RE: MVC Draft Amendment 4/2020 - Meander Valley Council further submission in response to TPC direction of 29 July 2021.

Meander Valley Council
Draft Amendment 4/2020 - Country Club Estate
Further Submission to TPC Direction 29 July 2021

Figure S23.1 Development Plan

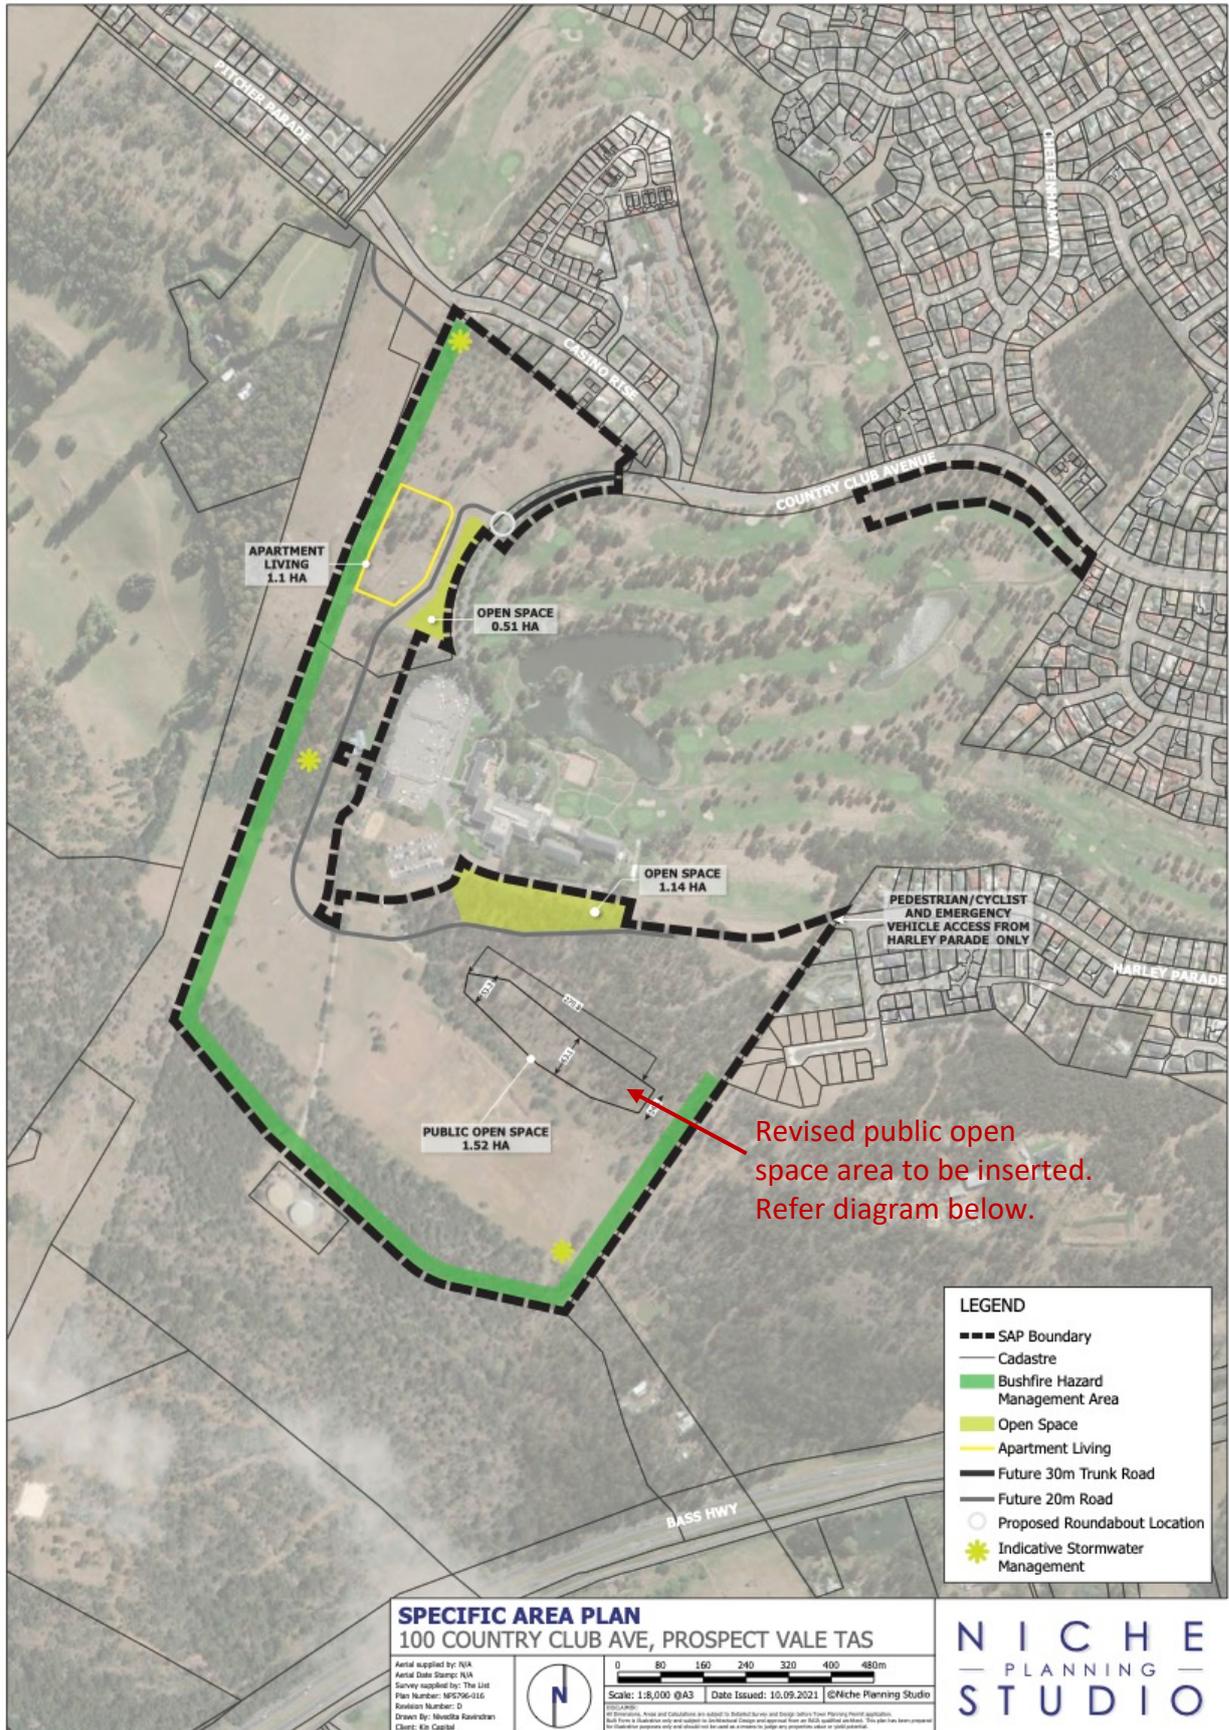
Objective	<p>That subdivision provides for:</p> <ul style="list-style-type: none"> (a) public open space over the central ridgeline; (b) the location of future collector roads and junctions that integrates with the existing and future road network; (c) a lot for apartment living; (d) a bushfire hazard management area; (e) open space areas to buffer the Country Club Tasmania complex; and (f) key stormwater management locations.
Acceptable Solutions	Performance Criteria
<p>A1</p> <p>Subdivision must be in accordance with the development plan at Figure S23.1.</p>	<p>P1</p> <p>Subdivision must be consistent with the purpose of the Specific Area Plan having regard to:</p> <ul style="list-style-type: none"> (a) the topographical or natural features of the site; (b) any requirements for bushfire hazard management areas; (c) the provision of a hierarchy of local and collector roads; (d) pedestrian connectivity; and <p>must include the public open space in accordance with Figure S23.1.</p> <p><i>Note: In its Section 39 Report of April 2021, Council agreed to a revised area of public open space submitted in the representation by Niche Planning Studio. Figure S23.1 will be revised to reflect that change.</i></p>

Revised Public Open Space configuration:
